33-47 Eastern Promenade

In ref to Portland House

45 Eastern Promenade
Portland House

EASTERN PROMENADE - PORTLAND, MAINE

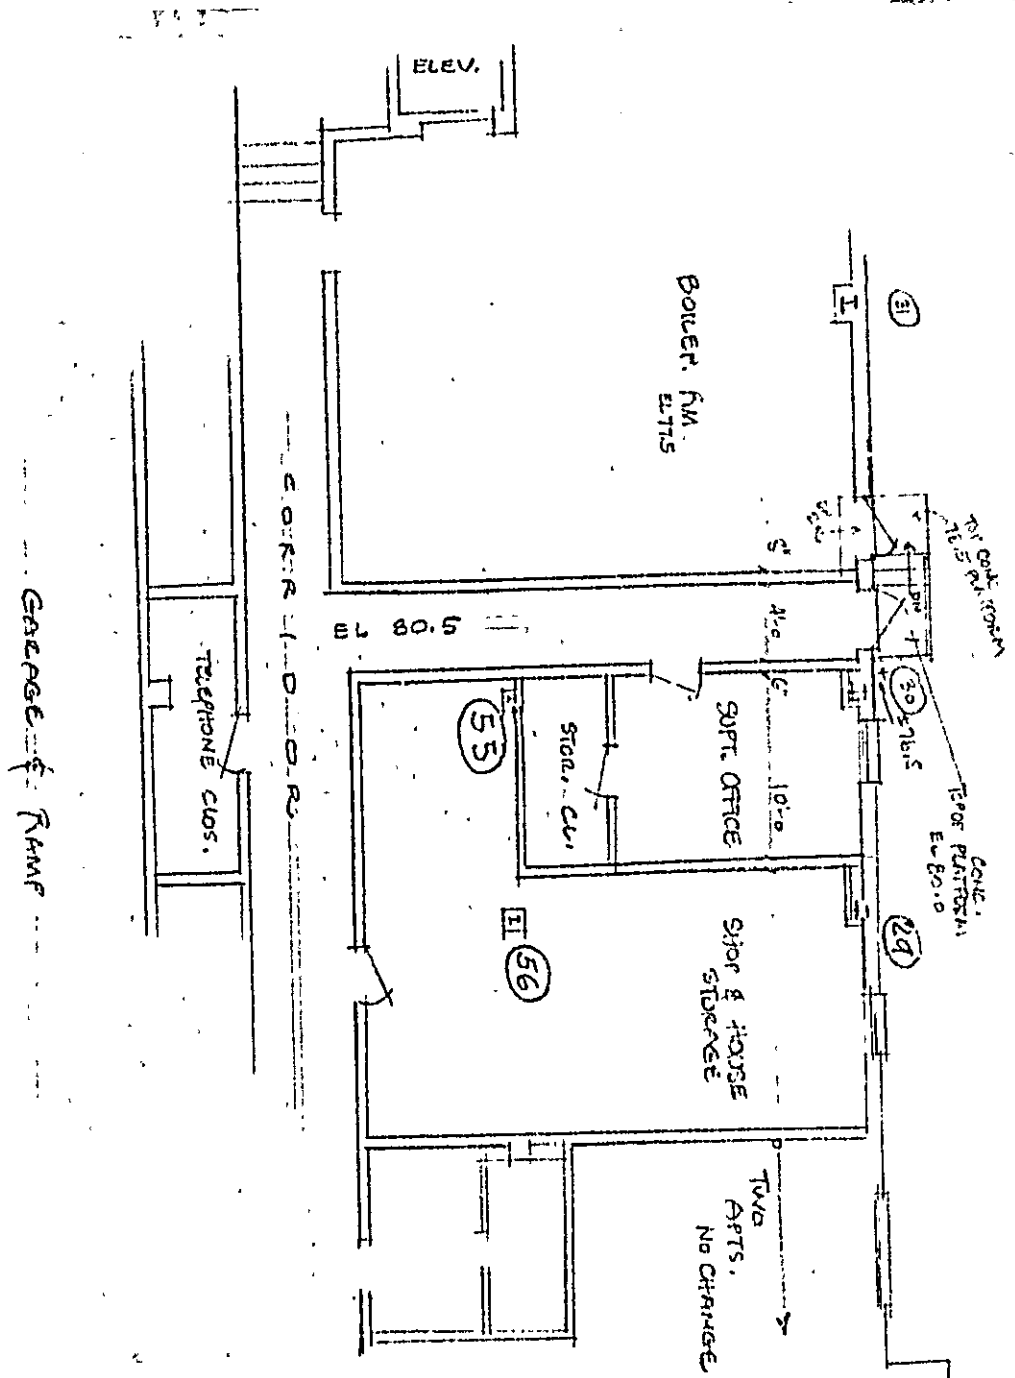
- A. Corrulux Panels at balcony dividers.
- B. Second exit from basement at 1st Garage level.

Regarding the Corrulux panels, these will be Johns Manville, Standard Pyro Panel, rated by Underwriters Laboratories as Flame Spread 35. These panels come labeled to show quality and Flame Spread rating. They ignite at about 850°-900° F. (See page 5 of enclosed brochure.)

1. It is understood that you are to revise your plans to provide the second means of egress from stairwell number 2 more directly out-of-doors as per your revised print received December 18, 1967. This means of egress is to be lighted and marked with exit and directional signs which will need to be shown on your revised plans.
2. The Standard Corrugux Pyro panels are acceptable for use as balcony dividers.

PROPOSED REVISION TO ADD
 ANOTHER MEANS OF EGRESS
 AT 1ST GARAGE LEVEL.

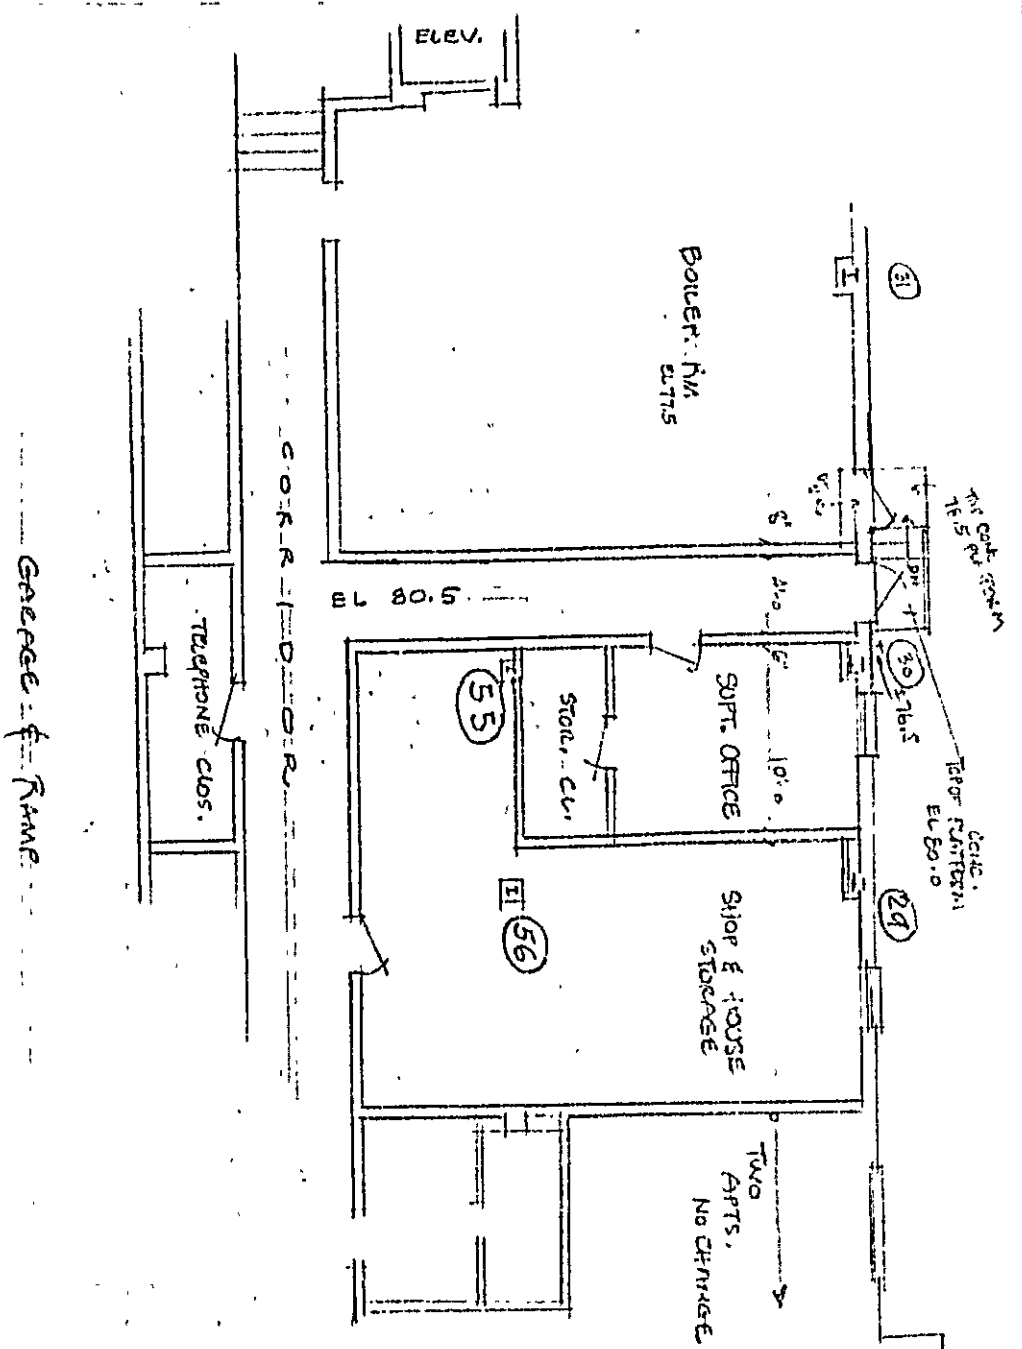
Regarding item B, I enclose herewith two prints of a sketch showing second exit from the south part of the basement at 1st garage level along columns #55 and #30. As I indicated to you at our meeting, this location of the second exit appears to be more direct and more feasible and you indicated your concurrence to this.
